**Re: Peer Review Response  
91 Beatrice Circle  
Belmont, MA**

**Peak Flow Comparison for Frontage Road  
91 Beatrice Circle  
Belmont, MA**

Supplemental Engineering Report  
for a  
Multi-Unit Residential Development  
91 Beatrice Circle  
Belmont, Massachusetts

Ground-water Mounding, in feet

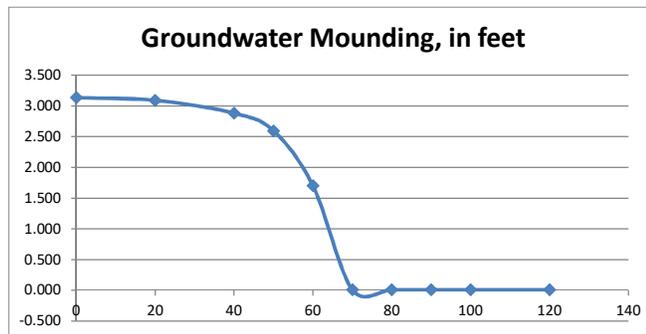
- The mounding analysis needs to be done with correct input parameters. We ran the correct numbers informally and they appeared to work but the Applicant should confirm.

DBS has attached a revised mounding analysis that shows the calculated groundwater mound does not have a negative impact upon the subsurface recharge structure and that it drains within 72 hours. The mounding analysis can be found in the Supplemental Engineering Report.

**PROPOSED OFF-SITE  
 WATERSHED MAP  
 91 BEATRICE CIRCLE  
 BELMONT, MASS.**

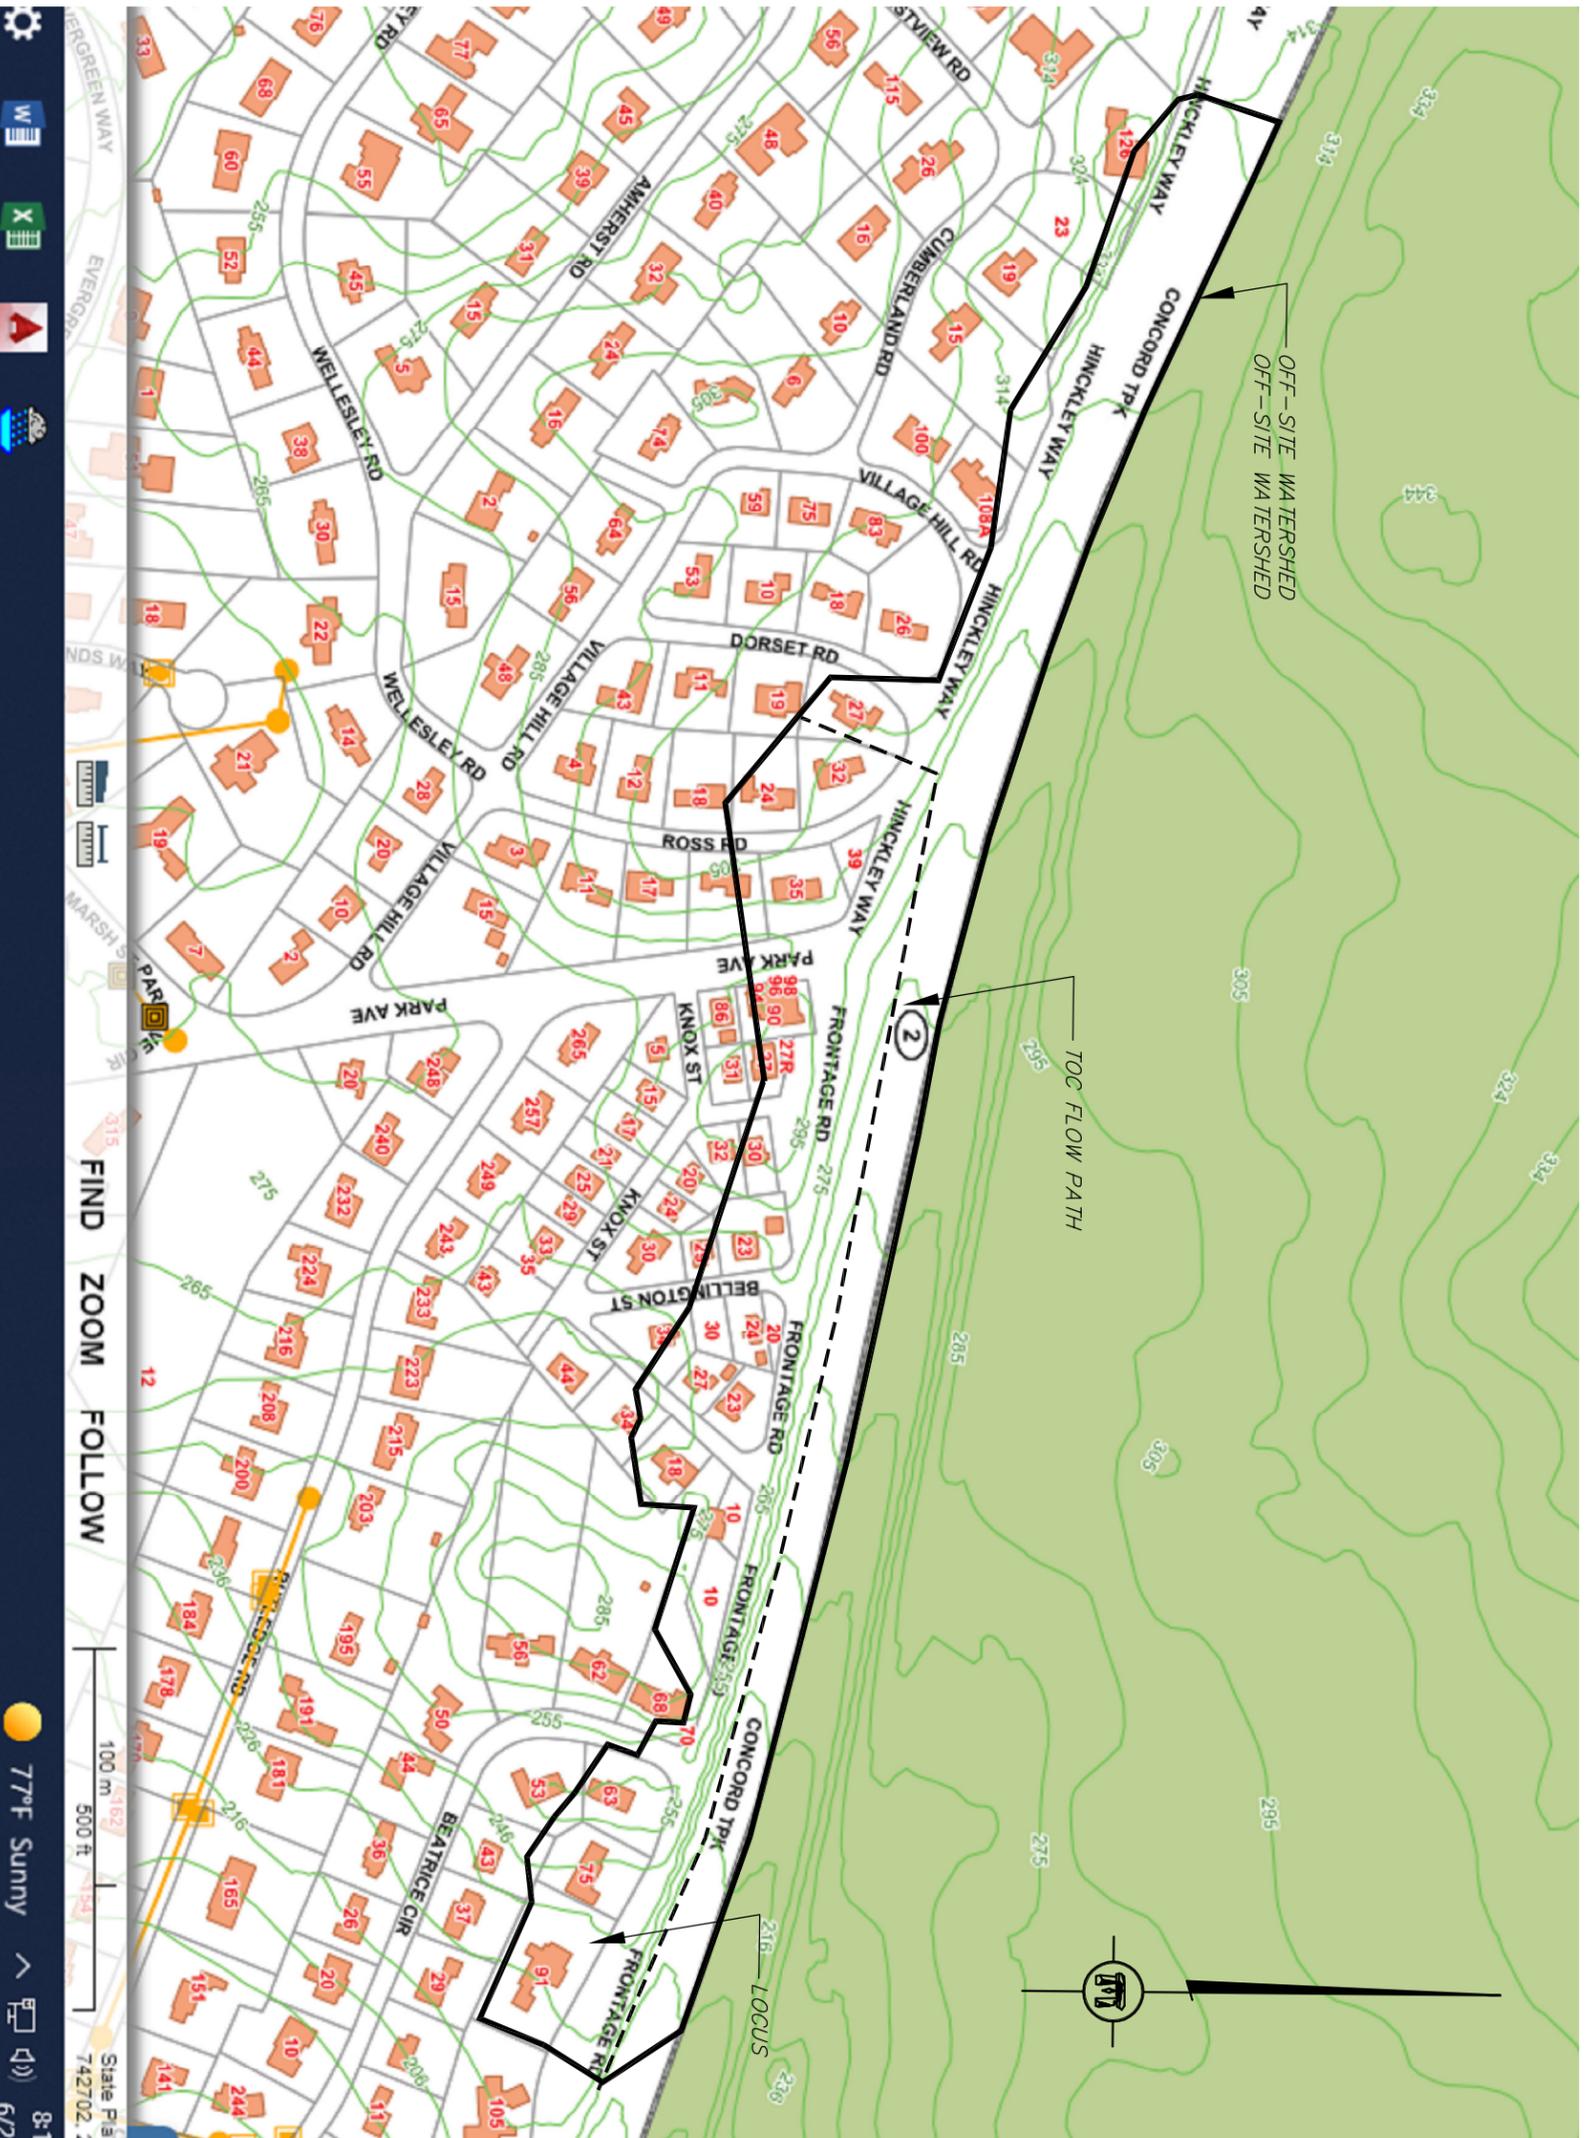
- Provide documentation/calculations that the proposed tie-in at Frontage Road.

DBS generated a watershed map that delineates the up-gradient watershed for the existing 15" drain pipe that runs along Frontage Road at the project locus, 91 Beatrice Circle. The watershed area is 618,294 square feet (s.f.) and we provided an existing coverage number (CN) of 61 for existing conditions and calculated a time of concentration of 9.9 minutes. The existing drain pipe is a 15" reinforced concrete pipe with a slope of 7.7%.

DBS has attached the watershed map, the HydroCAD calculations for the existing condition off-site drainage analysis, the HydroCAD calculations for the proposed condition off-site drainage analysis and comparison summary sheets showing peak flows and flow depth for the 15" pipe.

LEDGE REMOVAL VOLUME PLAN

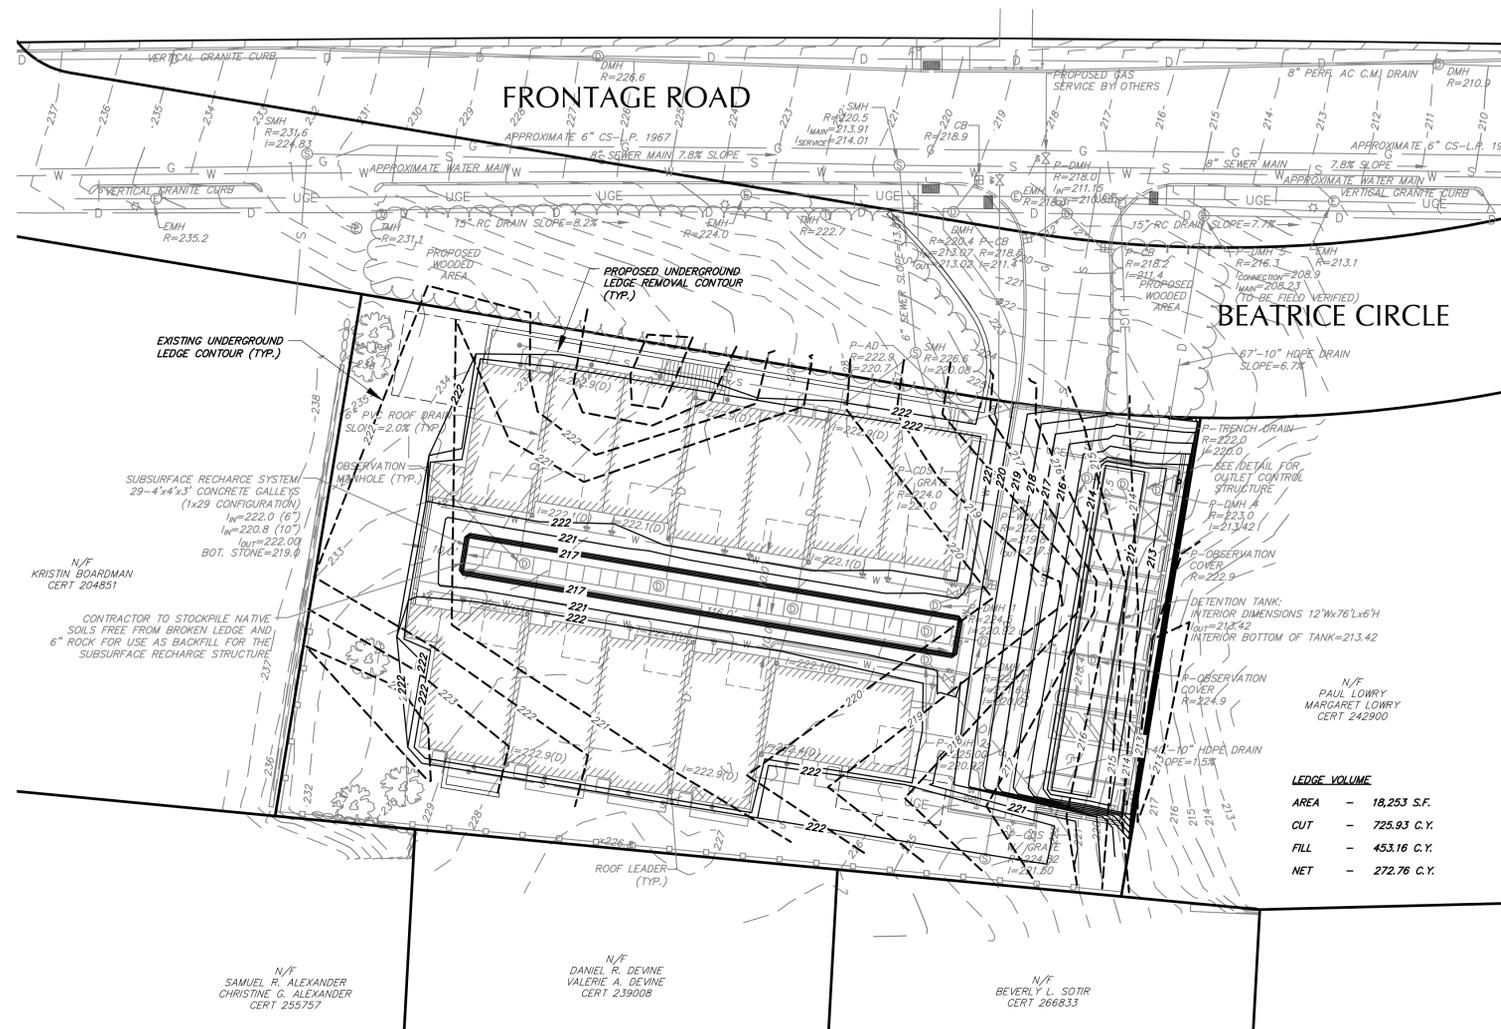
- Provide more detail on how the apparent ledge will be dealt with at the site.

DBS has generated a plan showing estimated ledge contours calculated by interpolating between the ledge elevations found in each test pit. A copy of this plan is attached to this letter. In addition DBS estimated the underground excavation required for this site and created a surface using Civil 3D AutoCAD software. A ledge removal volume of 726 cubic yards was calculated with a maximum depth of 3.5 feet for the installation of the detention tank. The applicant proposes to remove the ledge by hydraulic hammer. No blasting is proposed for this site.
